Comment # 33

John D'Ambrosia, Futurewei, U.S. Subsidiary of Huawei

IEEE P802.3cw TF Interim Teleconference Meeting
August 30, 2021

Proposed Partitioning Example - add to Annex 120A

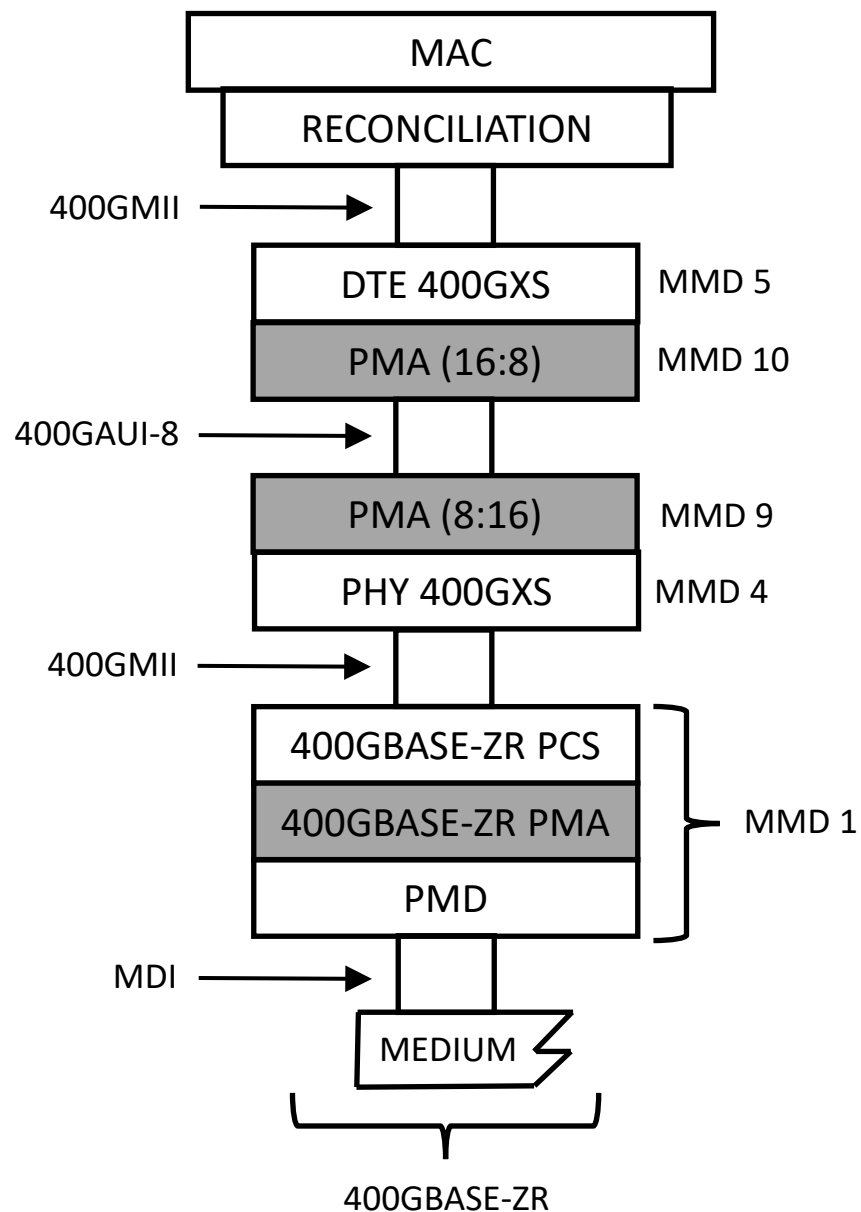
- Comment #33:
 - Given the potential different stack configurations, this annex (Annex 120A) should be used to illustrate different examples with the different PCS / PMA
- Proposed Remedy:
 - Presentation illustrating different concepts will be provided
